SIXTH ADDENDUM TO INVITATION TO BID
FOR THE DURHAM WRRF PHASE 6B DIGESTER PROJECT NO. 7203

ISSUED: OCTOBER 24, 2025

Clean Water Services' Invitation to Bid for the Durham WRRF Phase 6B Digester Project No. 7203 dated September 17, 2025 (ITB) is hereby amended as follows:

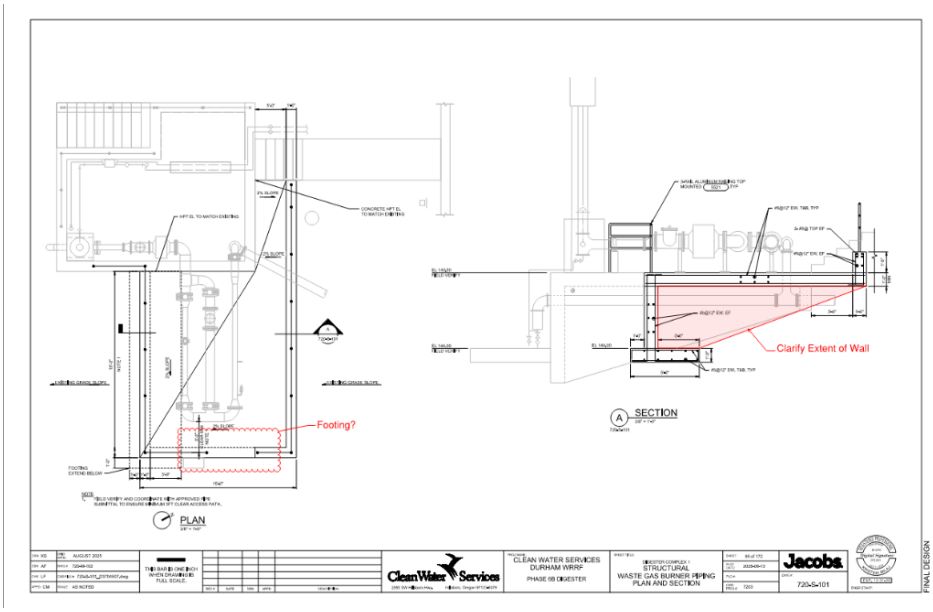
12. Question 12: I am looking for some clarification or detail on the cast in place concrete shown at the waste gas burner at digester 1. The end wall is shown with no footing beneath and the extents of the wall as well as final grade are not clear. Can you provide some clarification, detail, or possibly a cut through this section if possible. Please see the mark-up below for reference.

Answer 12: There isn't a footing beneath the slab clouded on the plan view. The footing wall extends only to the 3'-0" dimension shown. The rest of the slab is on grade. In Section A, the existing grade rises at a constant slope from the lower slab on grade (EL 144 feet) to approximately the top of new wall (EL 151 feet). The area around the footing wall will be backfilled and existing grades will be blended starting at top of new slab on grade and sloped downward to match existing. See Drawing 005-CY-102 for existing and new contour information included in Exhibit A of this Addendum.

SHEET TITLE: GENERAL — PIPING SCHEDULE

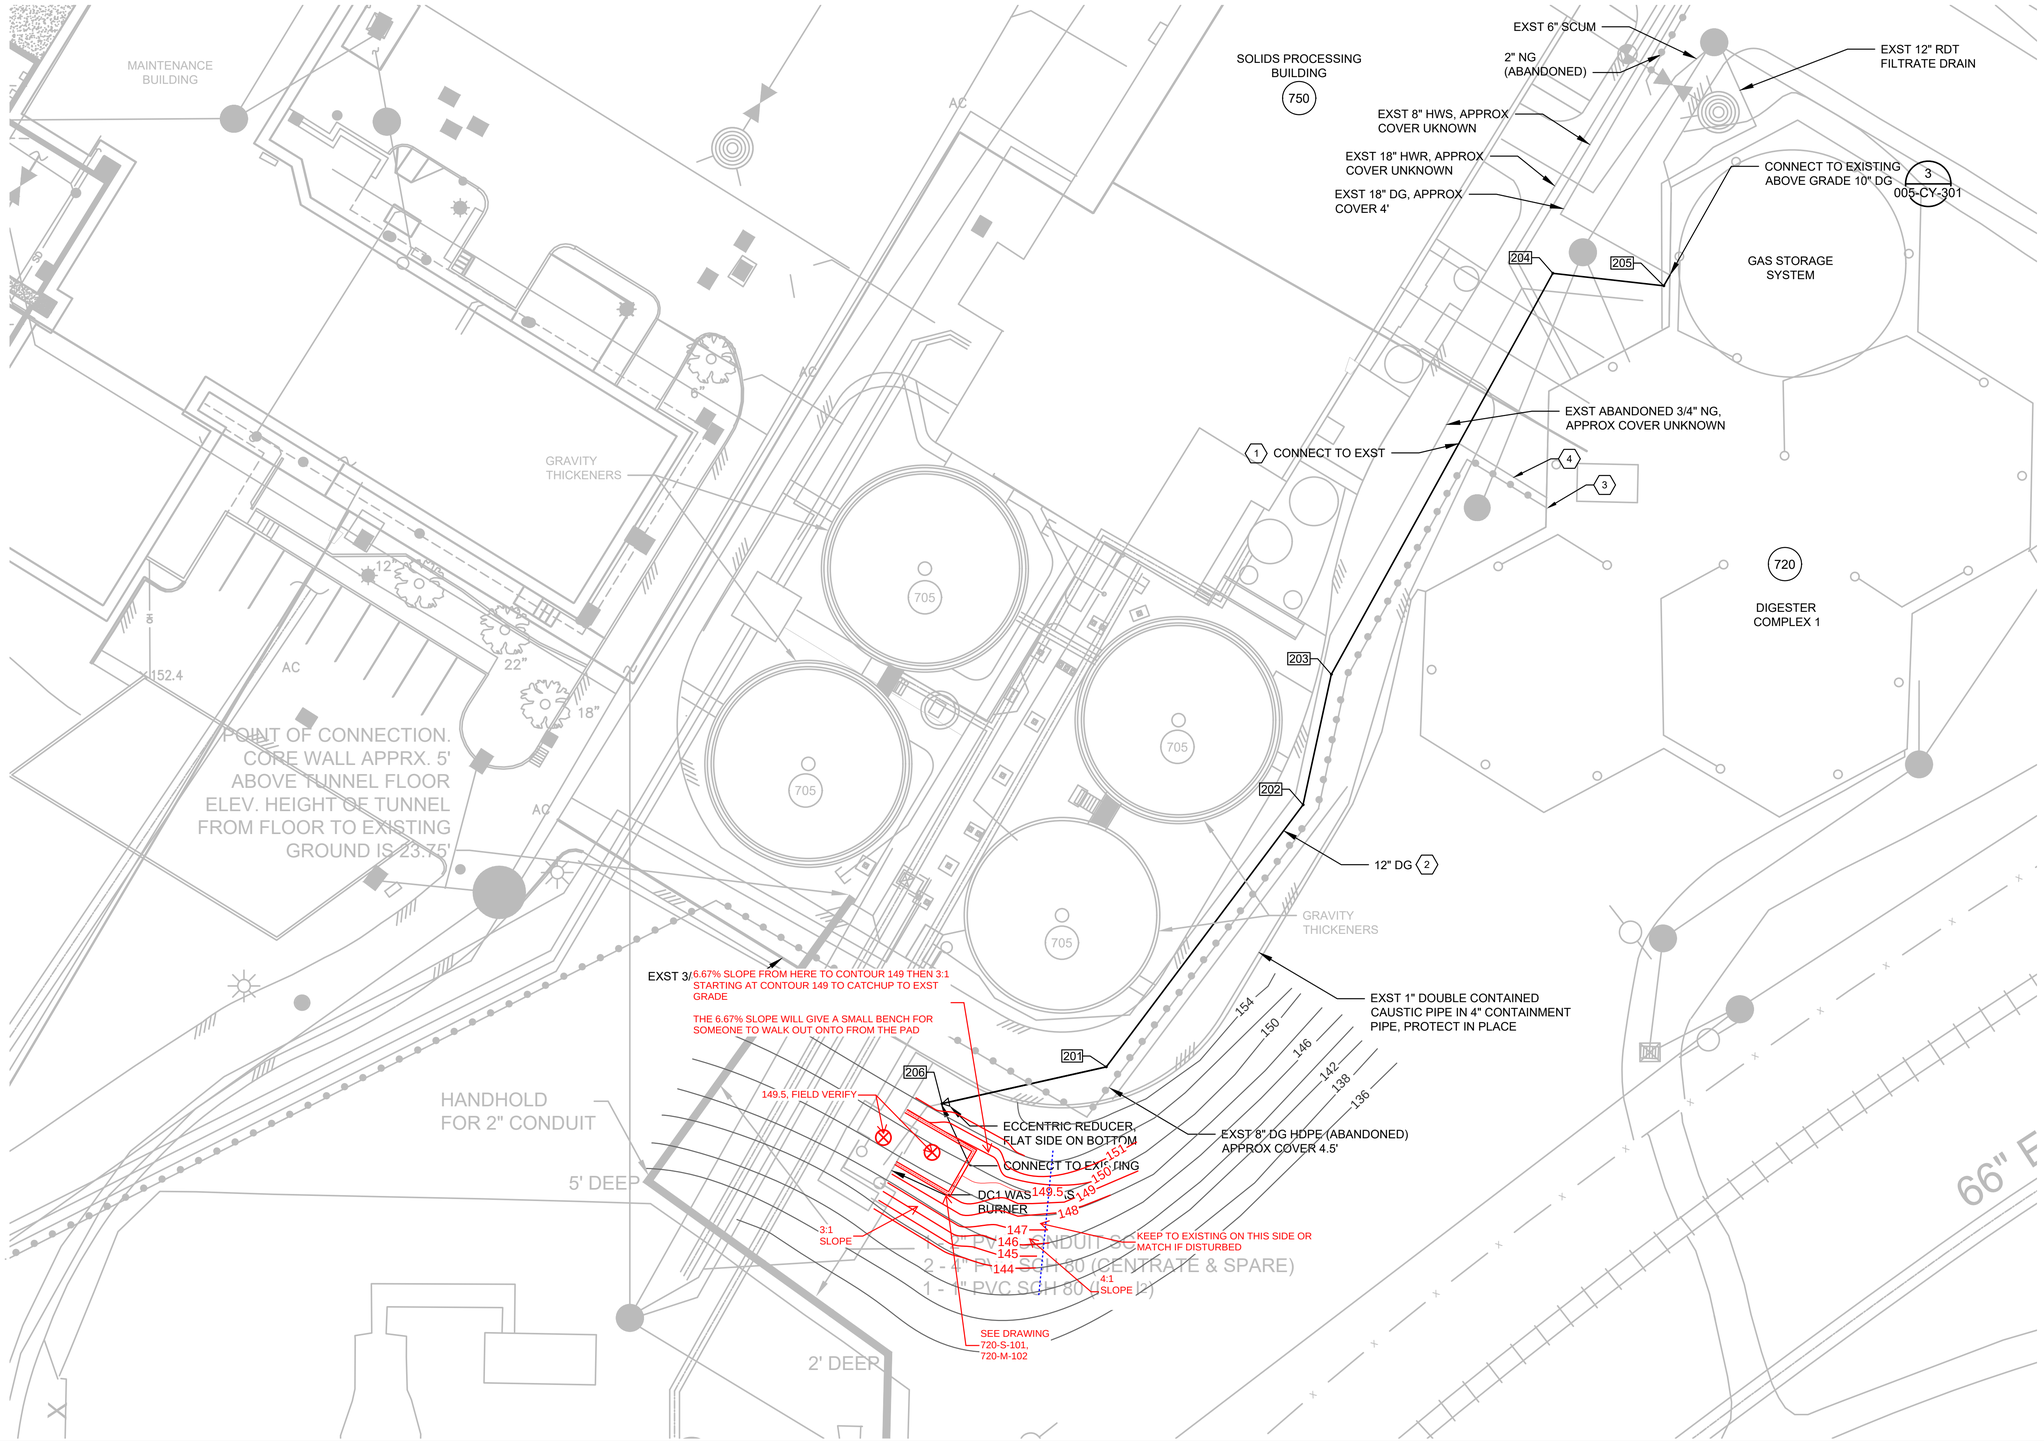
1. 001-G-086

Modify the piping schedule to include flowstream "DSL/DF" and revise the type of coating for buried DF piping to "POLY" in lieu of coating system No. 4.

7. Question 7: Drawing 005-CY-101. The 8" line going into the digester has two flowstream codes applied to it DSL and DF. Which one of these flowstream materials are we using? The Piping schedule pg. 001-G-086. calls out GLDI for the DF piping and CLDI for the DSL.

Answer 7: Refer to revised Drawing 001-G-086 included in Exhibit A of this Addendum. Piping identified with flowstream DSL/DF shall be glass-lined ductile iron.

SHEET TITLE:
SITE DEVELOPMENT
CIVIL
YARD PIPING PLAN
AREA 2

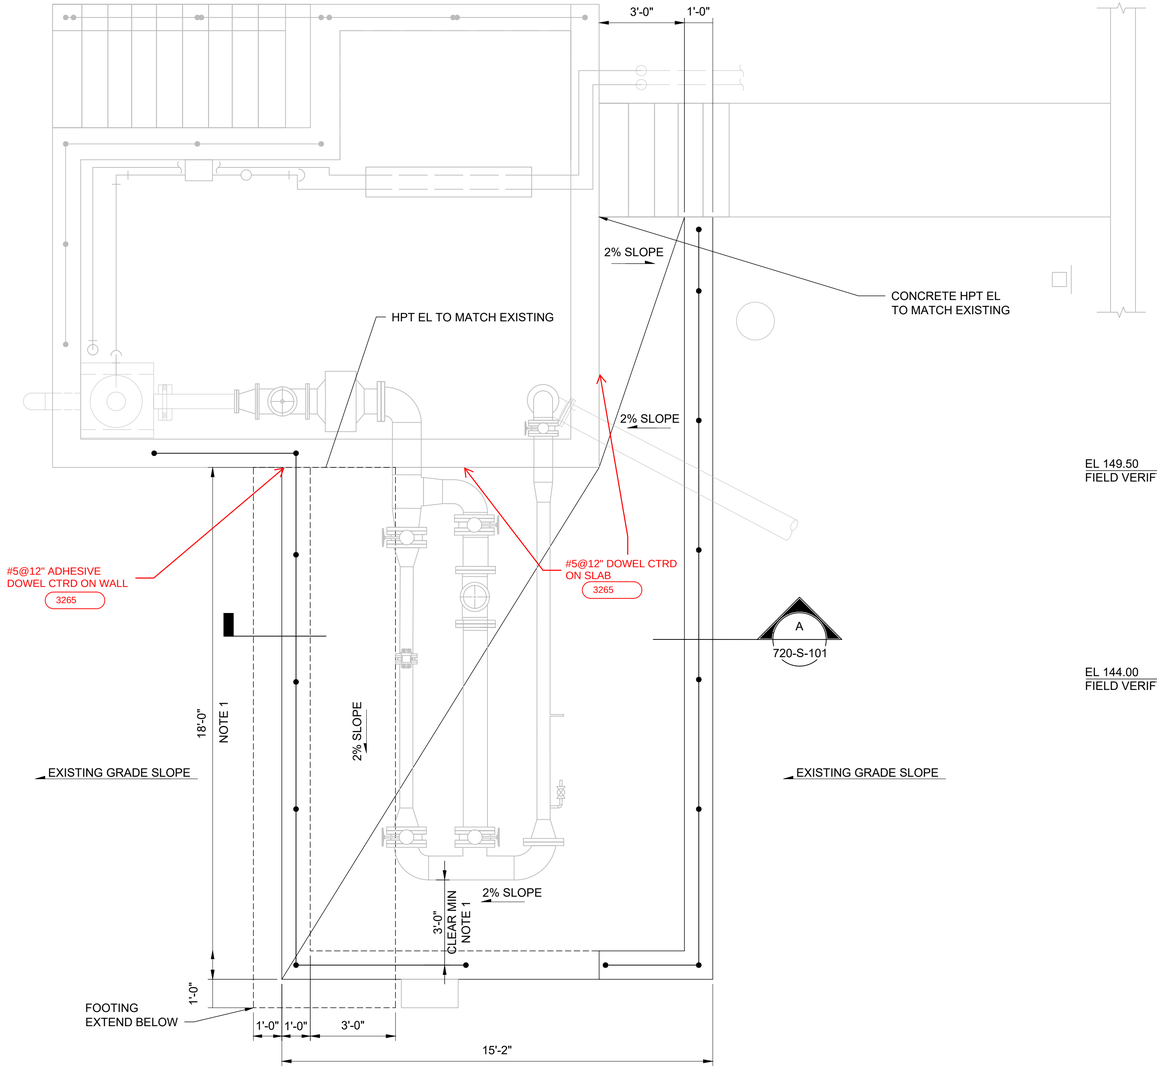
2. 005-CY-102

Existing and new contour information was added around the DC1 Waste Gas Burner.

SHEET TITLE: DIGESTER COMPLEX 1 STRUCTURAL WASTE GAS BURNER PIPING PLAN AND SECTION

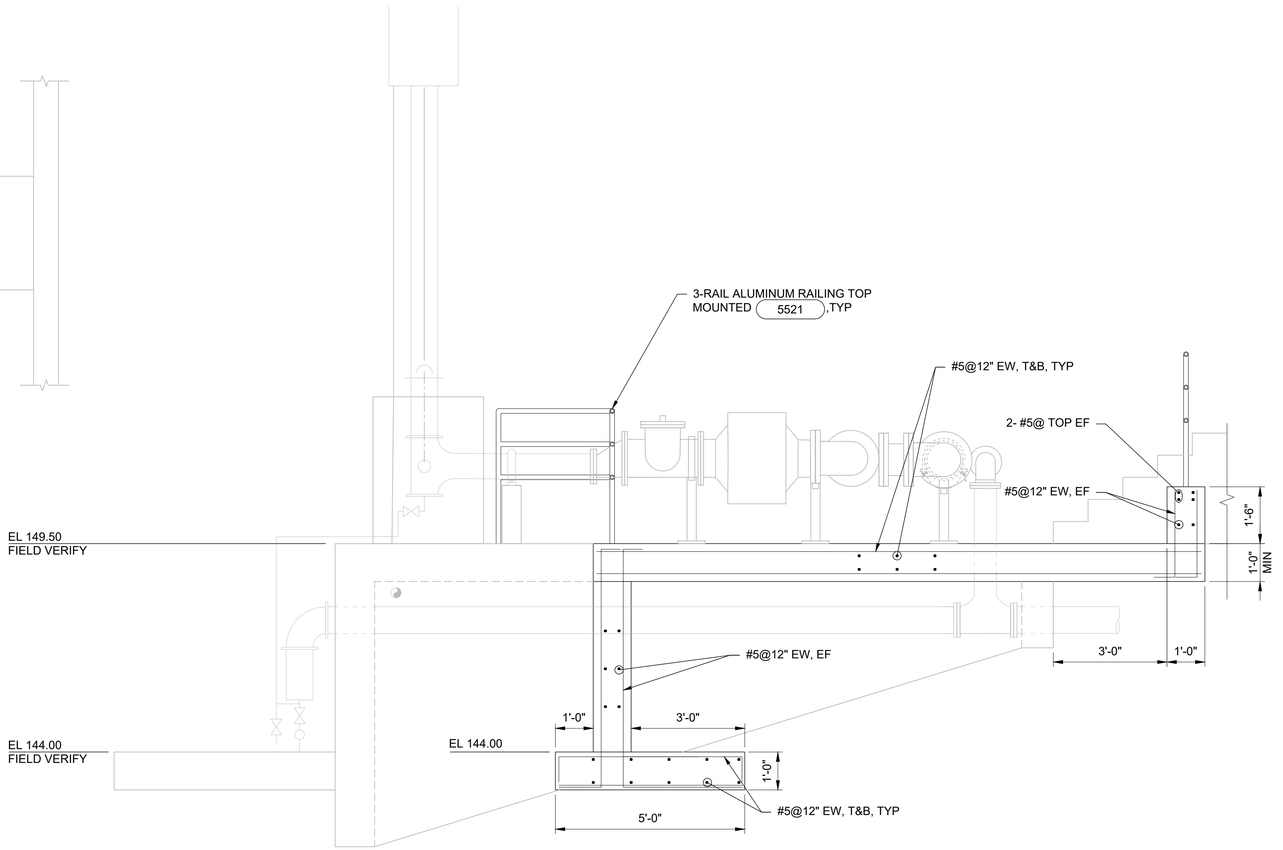
3. 720-S-101

Add reinforcing dowels between the new and existing concrete as shown.

1. Question 1: Drawing 720-S-101. The footing appears to terminate ~7' prior to edge of wall. Should the remaining ~7' of wall be resting on structural fill or continue the footing to mirror Section A?

3. Question 3: Drawing 720-S-101. Please clarify if the new concrete for the gas burner pad/walls are intended to be tied into the existing structure with any reinforcing dowels, as none are shown.

Answer 1: Correct. The footing terminates at the 3'-0" dimension (dashed line). The remaining is slab on grade on structural fill.

Answer 3: Reinforcing dowels have been added on Drawing 720-S-101 included in Exhibit A of this Addendum.

SHEET TITLE: DIGESTER COMPLEX 2 CONTROL BUILDING
PROCESS MECHANICAL
BASEMENT UPPER PLAN

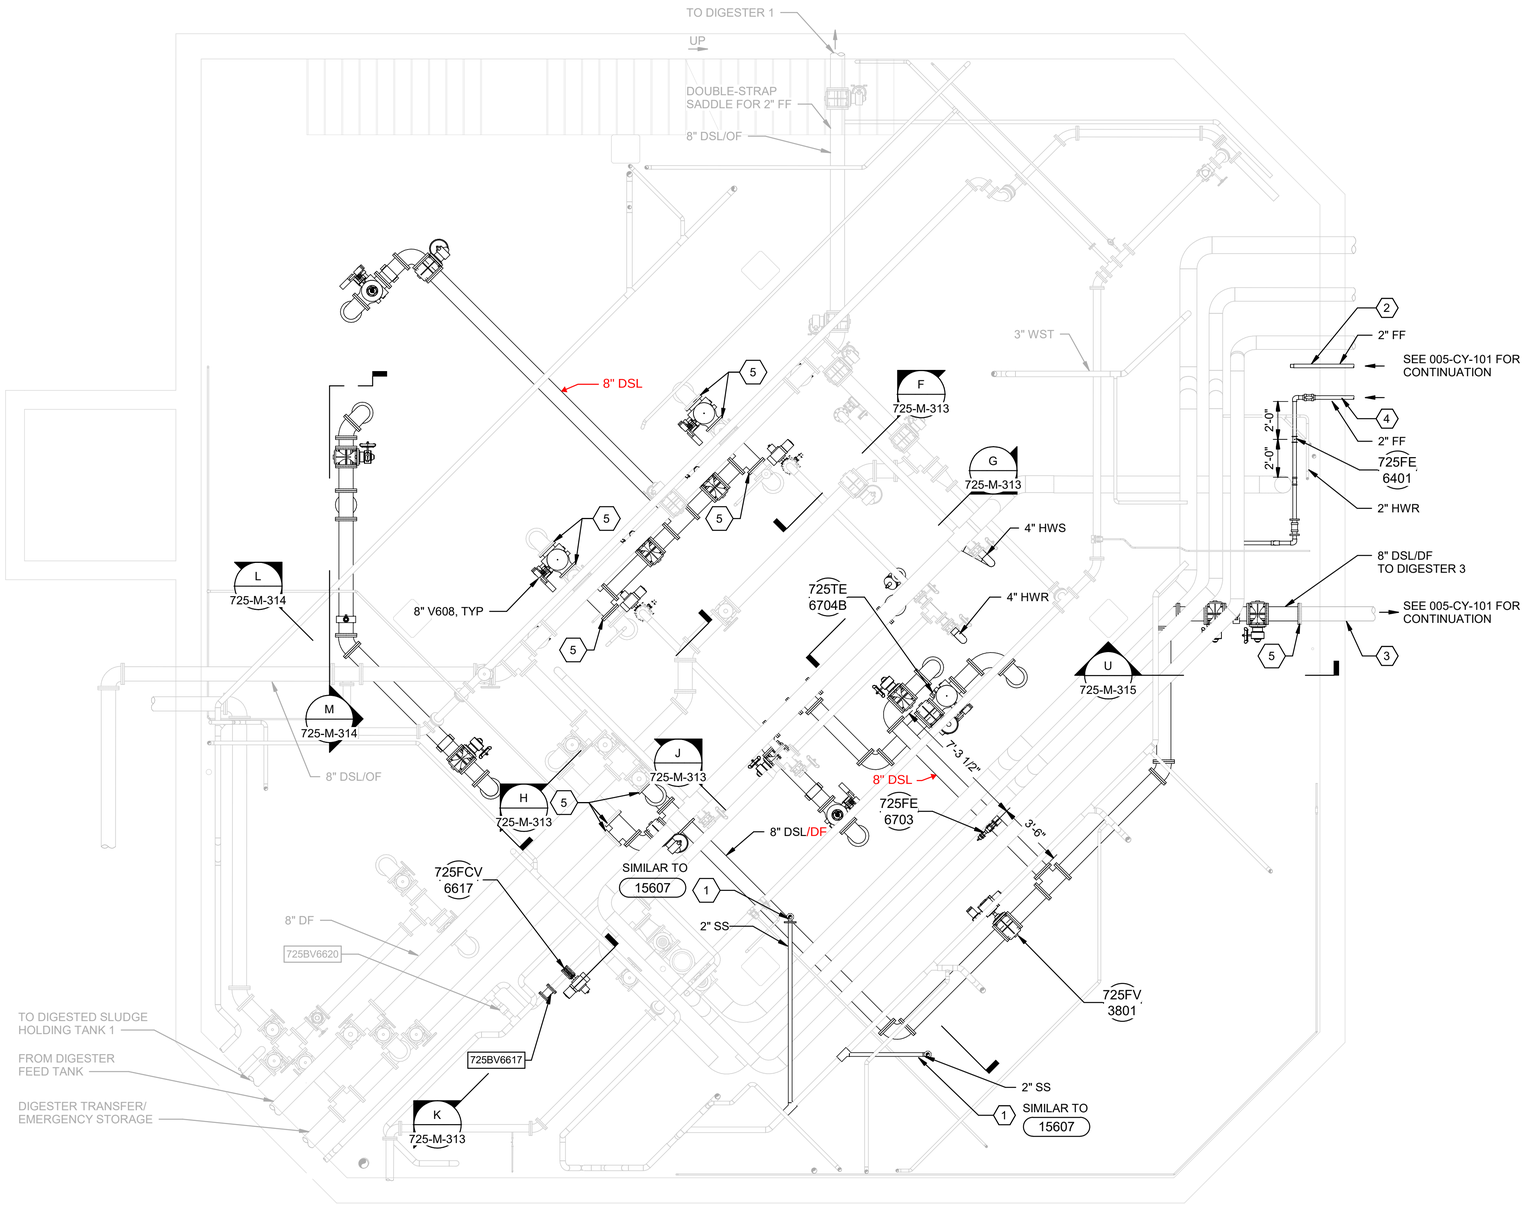
4. 725-M-111

Modify and add callouts to the Basement Upper Plan to clarify the pipe flowstream and service. Pipe material, lining, and coating requirements are specified in the Piping Schedule on Drawing 001-G-086.

SHEET TITLE: DIGESTER 3 ARCHITECTURAL ROOF PLAN

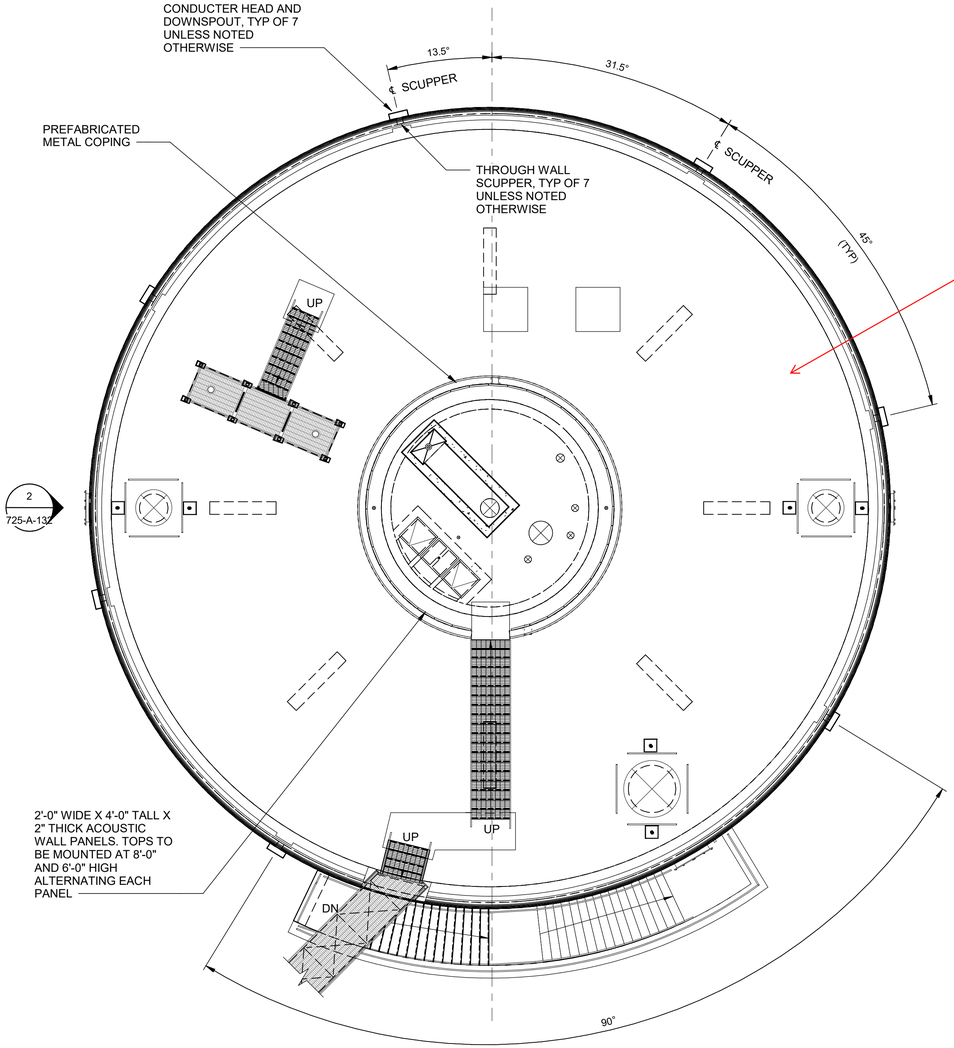
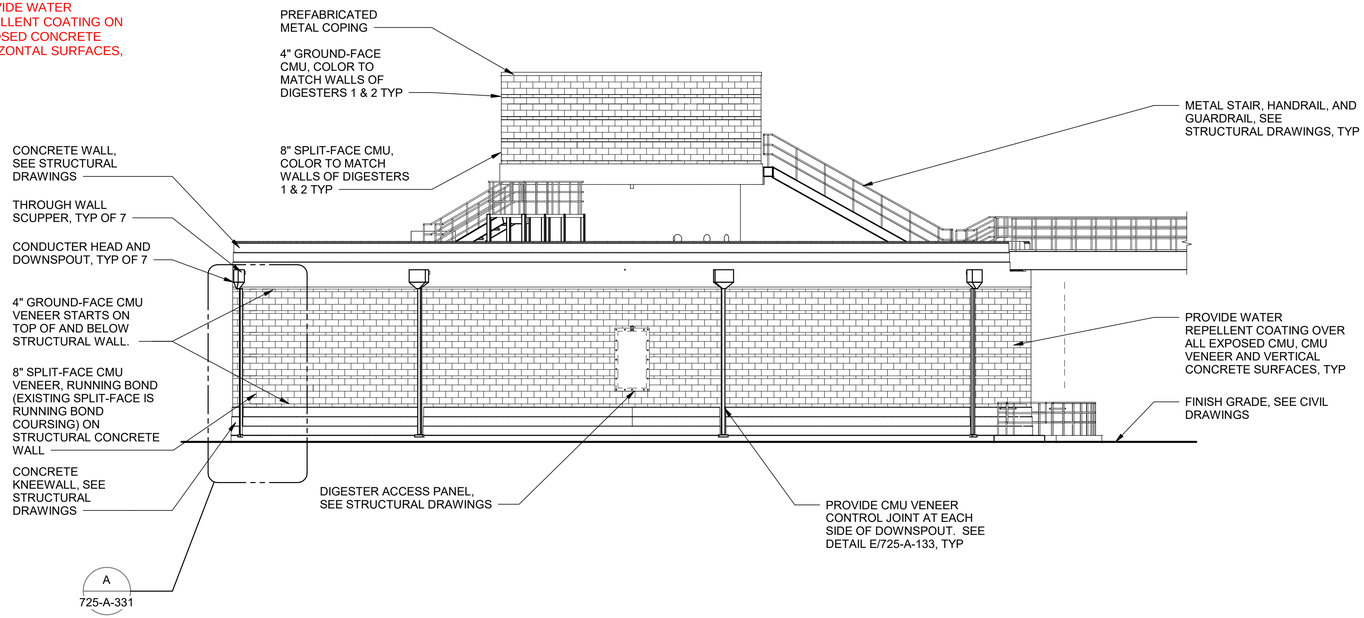
5. 725-A-132

Horizontal concrete surfaces shall also receive a water repellent coating.

5. Question 5: Section 07190 Water Repellents: Spec 07190 calls for water repellent on the vertical concrete and masonry surfaces of digester 3. Will any water repellent be required on the exposed horizontal concrete?

Answer 5: Water repellent to be installed on the exterior horizontal concrete surfaces as well.
